Thank you for the opportunity to comment on the application and associated information submitted to IPART in relation to Menangle Park Contributions Plan (the CP).

RE: PUBLIC EXHIBITION OF THE DRAFT MENANGLE PARK SECTION 94 CONTRIBUTIONS PLAN

Table 1 – Analysis of Section 94 Plan and Dahua Comments

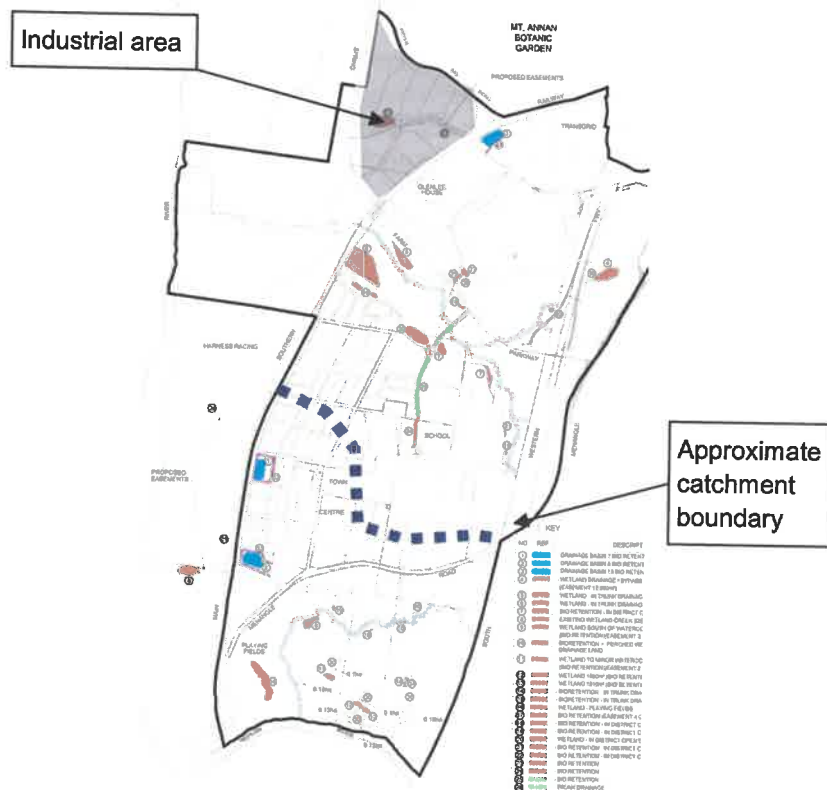
- The Industrial IN1 land comprising its own catchment, and being solely responsible for the drainage items D1.15 (#17 on map Figure 5) and D1.21 (#27 on map Figure 5). It is unreasonable for industrial uses to be required to contribute to the remainder of the precinct's drainage system.

- The remaining residential and retail developable area and the drainage facilities within that are being split into two contribution catchments. The boundary between these two catchments would be the ridgeline between the main northern watercourse which flows in a westerly direction, and

the shorter southern watercourse which flows in a south-westerly direction. Approximate boundary shown in the figure above.

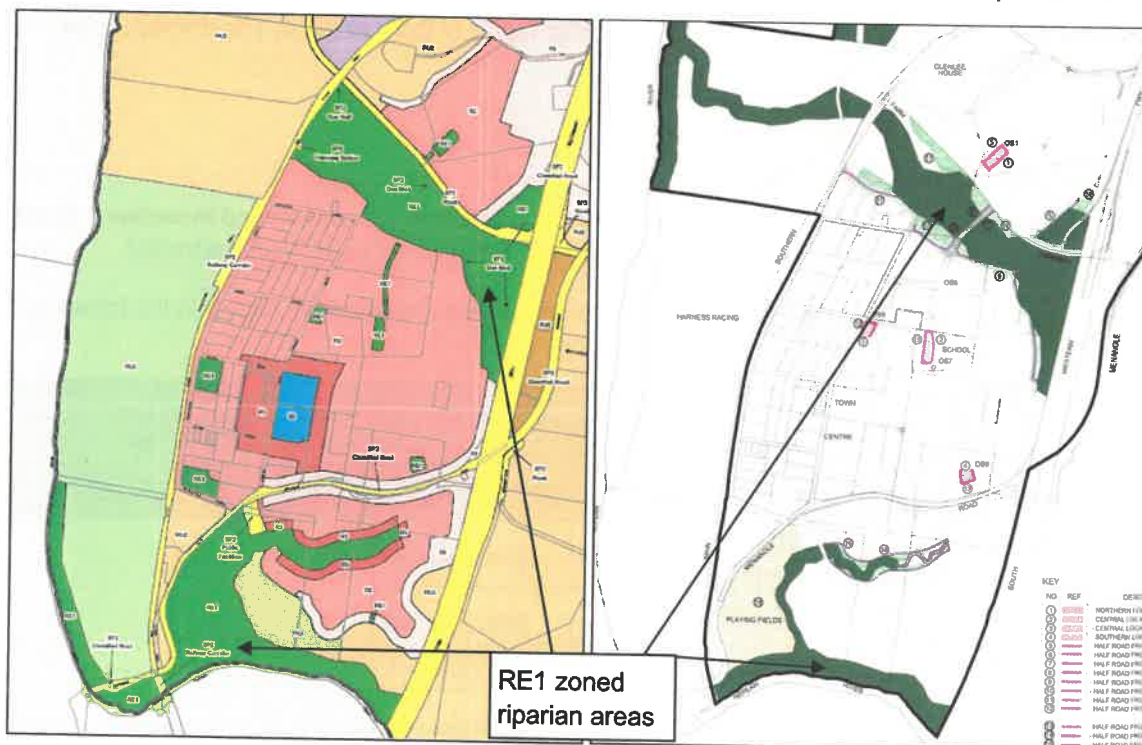
This land is proposed to be zoned RE1 Public Recreation under the draft LEP that has been prepared for the precinct (see figure below). Our understanding is that gazettal of the LEP is imminent.

The land is critical to the safe conveyance of stormwater runoff from the precinct development, and to avoid flooding of developable areas. The land will also be integrated with the passive and active recreation facilities in the precinct, allowing for bicycle and pedestrian connections between neighbourhoods and to and from the Nepean River (see figure below).

Dahua's view is that the cost of the acquisition of this land should be included in the draft plan. This RE1 zoning will place an onus on the Council to acquire the land in the future. Without the inclusion of this land in the section 94 plan, there is no other likely funding source for Council to acquire the land.
